UNITED STATES PATENT AND TRADEMARK OFFICE

APPLICATION NO.	FILING DATE	FIRST NAMED INVENTOR	ATTORNEY DOCKET NO.	CONFIRMATION NO.
10/074,959	02/12/2002	Avery J. Evans	SPEC-6150	6989

Office Action Summary

DETAILED ACTION

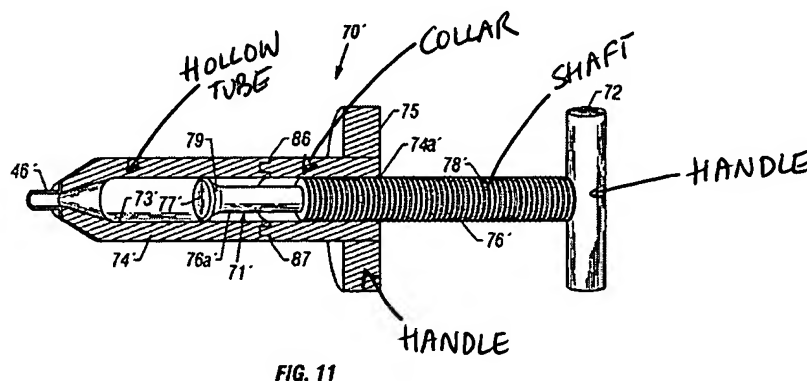
Claims 1-2, 4-5, 10, 15-16, 29 and 30 are rejected under 35 U.S.C. 102(e) as being anticipated by Preissman (US 6,383,190).

Preissman discloses a system for delivery of bone cement including: a plunger assembly with a shaft 76' having a threaded middle section and a handle 72 attached to a first end of the shaft; a dispenser hub assembly having a collar with an internally threaded portion and a handle 75; a hollow tube 74' removably engaged with the dispenser hub assembly; and a sealing element such as an O-ring 77' mounted on the shaft (Figs. 10-12C, 18, col. 11, lines 62-67, col. 12, col. 13, lines 1-13, col. 14, lines 11-67). Also see marked up Figure 11 below.
